Amendments to the Drawings:

Remarks/Argument

FIG. 31

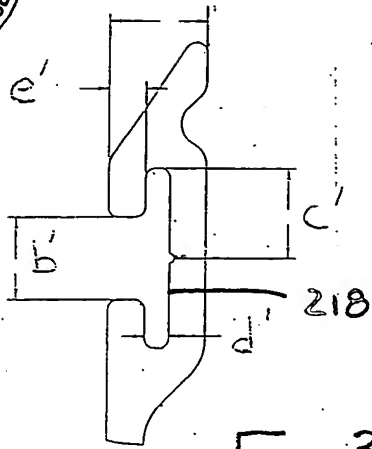
The attached sheets of drawings include changes to Figures 28-32. Figures 28-31 have been amended to add a reference numeral 218 to indicate the bottom wall of slots 211.

In the specification paragraphs [0095] and [0096] have been amended to provide a reference numeral for the bottom wall 218 of slots 211 of slot track 210. The drawings as filed and the claims as filed clearly show and recite a bottom wall. Figures 28, 29, 30 and 31 have been amended to add reference numeral 218. Applicants respectfully submit that the amendments to paragraph [0095] and [0096] and Figures 28 - 31 clarify the description of the slot track and the portion of the slot track referred to as the bottom wall. Applicants respectfully submit that no new matter is added, or intended to be added, to paragraphs [0095] and [0096] or Figures 28-31.

FIG. 28

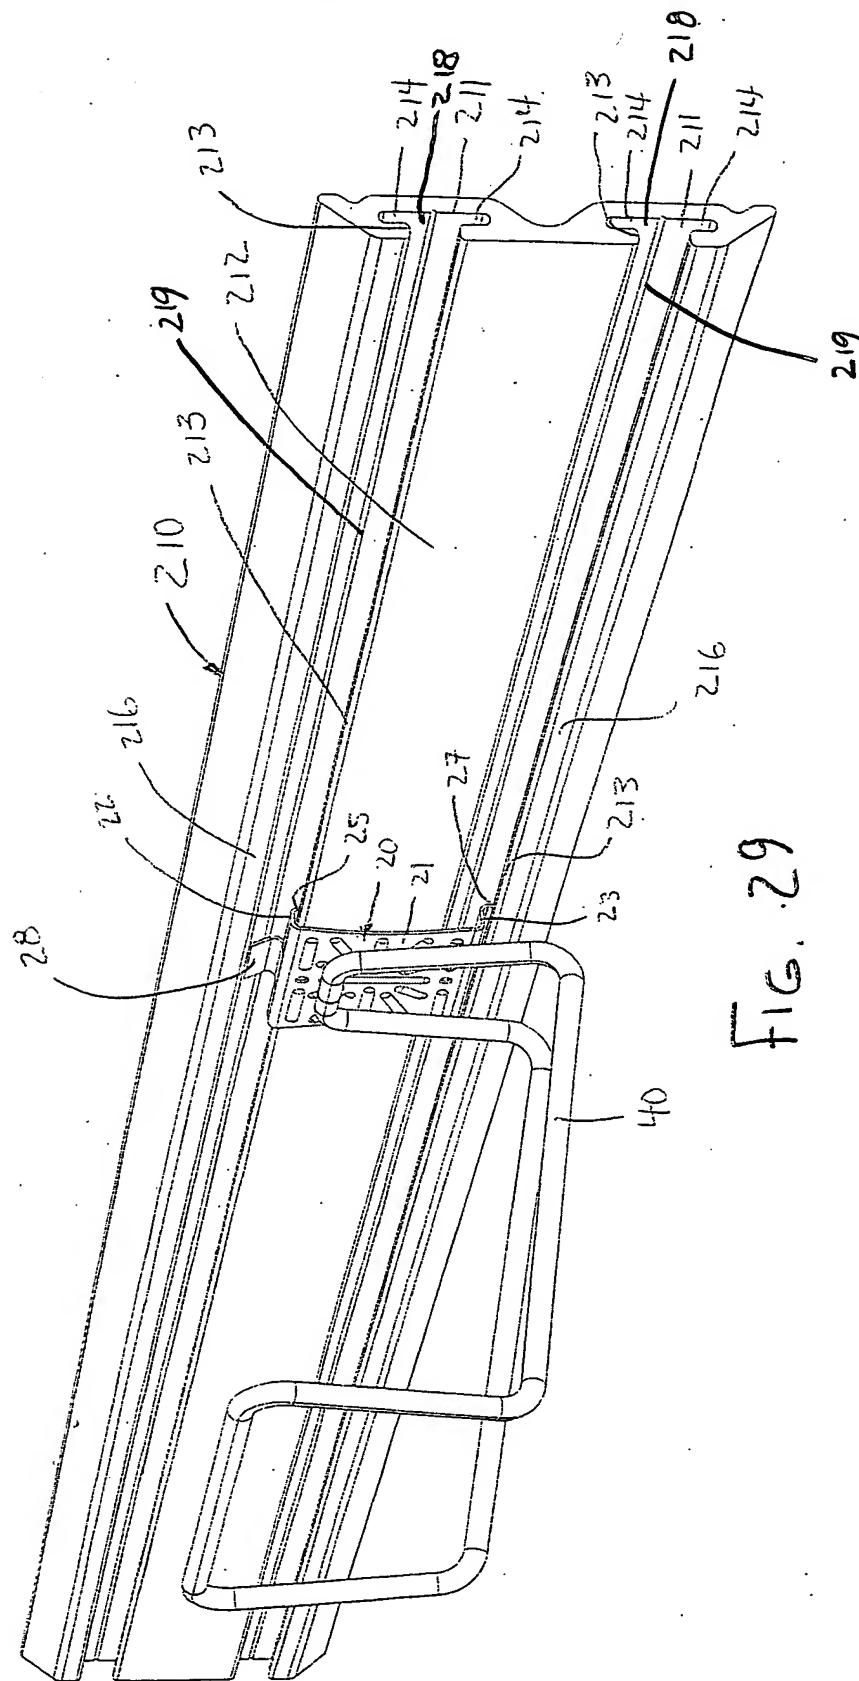
Claim 1 has been amended to clarify that adjacent slots 211, each having at least one undercut sidewall 214, form a slat 212 having a face with edges 213 defined by the slots. The bottom wall 218 is the bottom of the slot as shown in Figures 28-31 and is generally parallel to the face of slat 212. Applicants respectfully submit that while either adjacent or adjoining could be used to describe the relative position of two slots forming a slat, claim 1 has been amended to change adjoining to adjacent as proposed by the Examiner. Applicant respectfully submits that claim 1 as amended clearly describes the relationship of the elements of the slot track.
